CERTIFICATE OF APPROPRIATENESS

Applicant: Sheryl Kolasinski, owner

Property: 1447 Oxford St, Lot 1, Block 161, Houston Heights Subdivision. The property includes a historic 1,498 square foot, one-story wood frame single-family residence and a detached garage situated on a 6,600 square foot (66' x 100') corner lot.

Proposal: Alteration – Construct a 325 square foot, 27'-2" wide by 12' deep screened in porch at the rear of the structure. The applicant received approval in November 2013 for the porch and proposes to revise the flat roof on the porch to a shed galvanized roof and increase the width from 25'-6" to 27'-2".

SOUTH SIDE ELEVATION

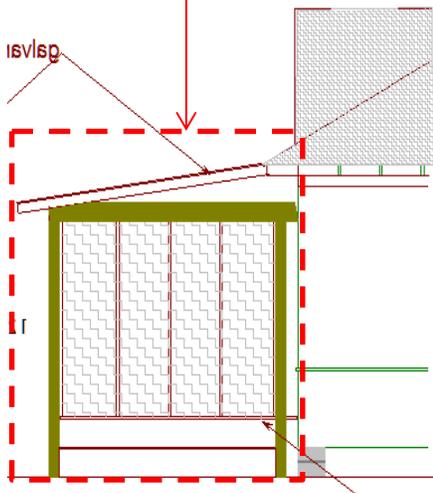
Side Elevation: The porch extends 12' from the back wall to the rear with five wood posts and railing.
(South)

WEST (REAR) ELEVATION

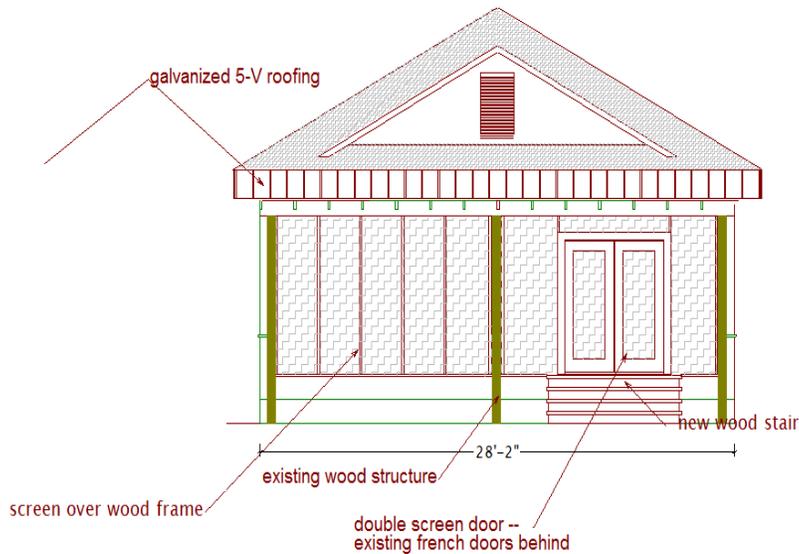
Rear Elevation: The porch contains a pair of wood, screened double doors and a stair.
(West)

**SITE PLAN
EXISTING**

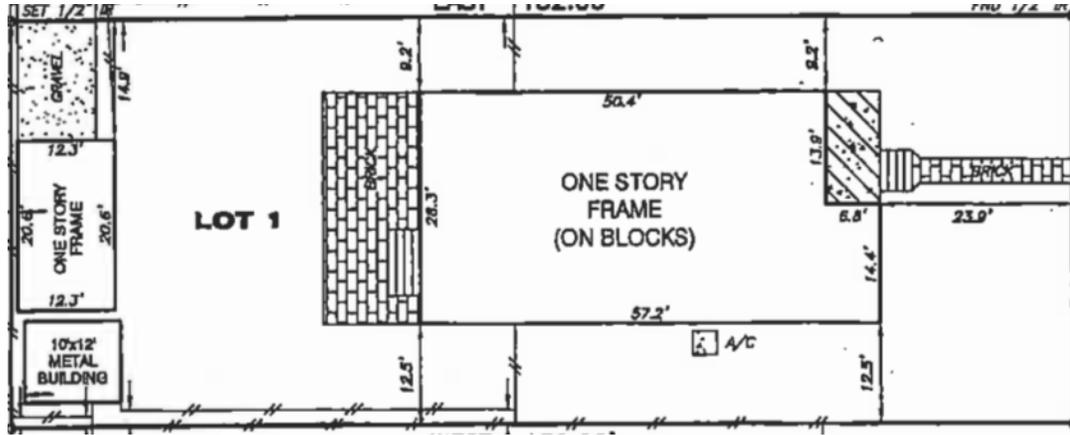
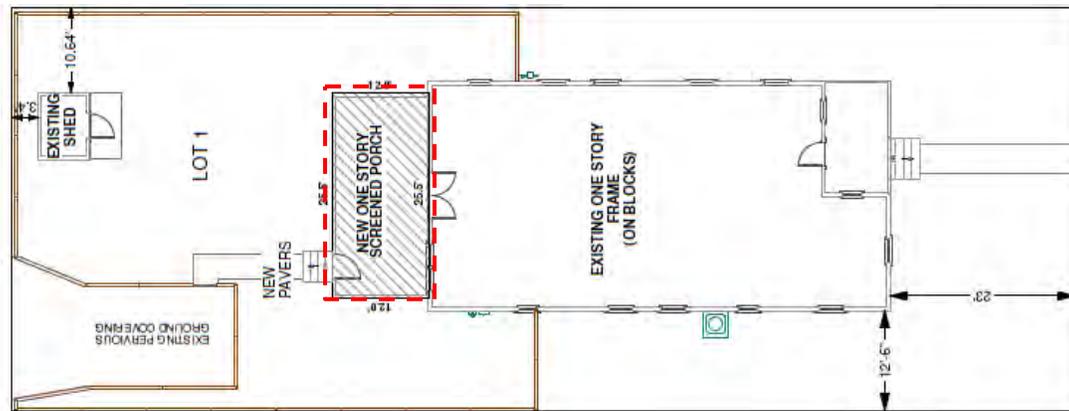
Shape/Mass: The existing residence is 28'-2" wide and 57' at its deepest. The screened in porch measures 27'-2" wide, 12' deep and 12' to the highest part of the ridge. It is set in from the side walls 6" on each side.
